Subject: I-93/Route 110/Route 113 Methuen Rotary Project (Project File No. 605181)
Attn: Environmental Services

LivableStreets would like to take this opportunity to provide comments regarding the 25% Design for the I-93/Route110/Route113 Methuen Rotary as presented to the community on January 11, 2011. This letter is accompanied by a modified version of MassDOT's alternative that attempts to illustrate our main points.

Exhibit 4.38. Example of Bike Lane and Freeway Interchange

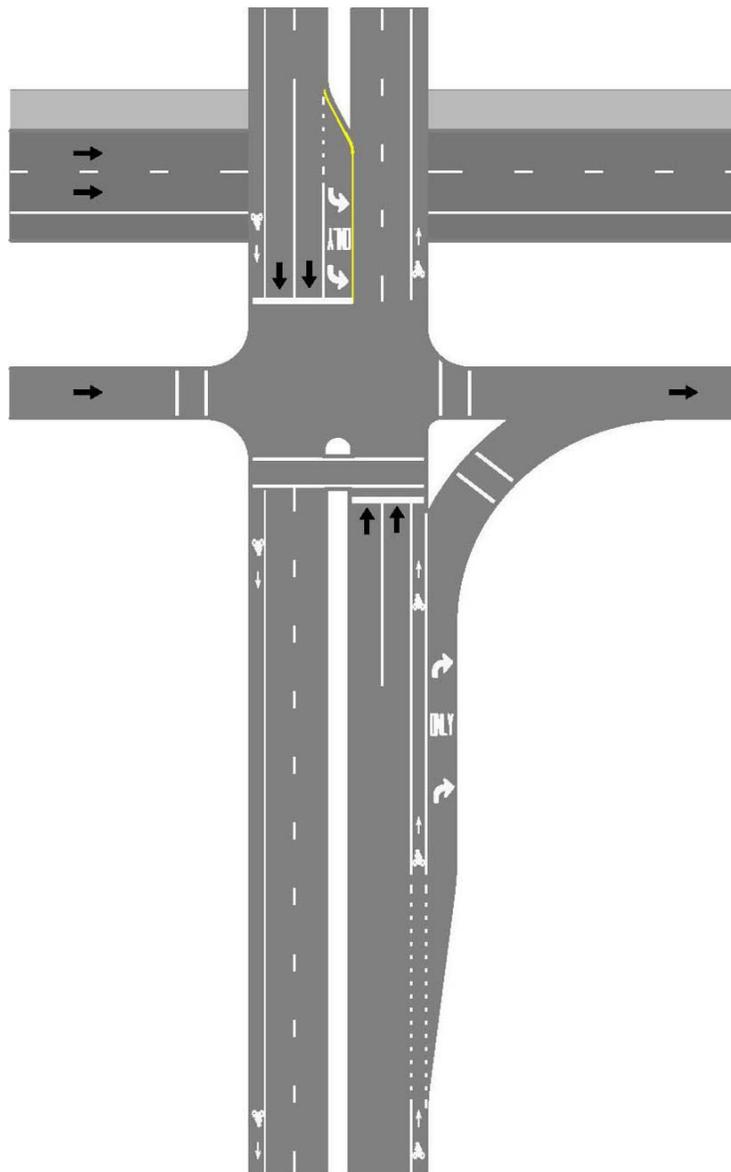
For most interchanges, we would recommend that the bike lane continue dashed to the left of on- and off-ramps, to help guide bicyclists straight ahead and alert motorists of where bicyclists are expected to be. The following diagram from the 2010 Draft AASHTO Bike Guide shows the general idea across a highway on-ramp. Note how the bike lane guide guides bicyclists across the on and off ramps and requires motorists to merge over the bike lane as opposed to requiring the bicyclists to merge over the travel lane.

Exhibit 4.41. Option 2 – Bike Lane and Off-ramp

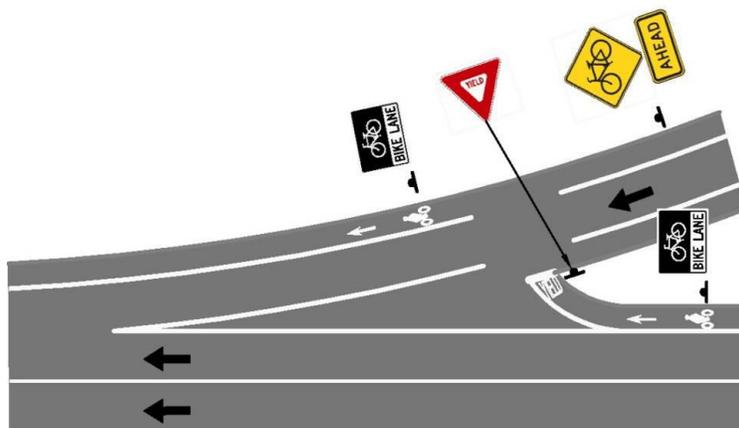
Continuing eastbound, since the exit from I-93 North going eastbound transitions into its own travel lane, we would recommend a treatment that guides bicyclists across this exit ramp at a right-angle as well. Here is an example this type of treatment from the Draft 2010 AASHTO Bike Guide (we would recommend that you continue the bike lane dashed across the ramp itself):
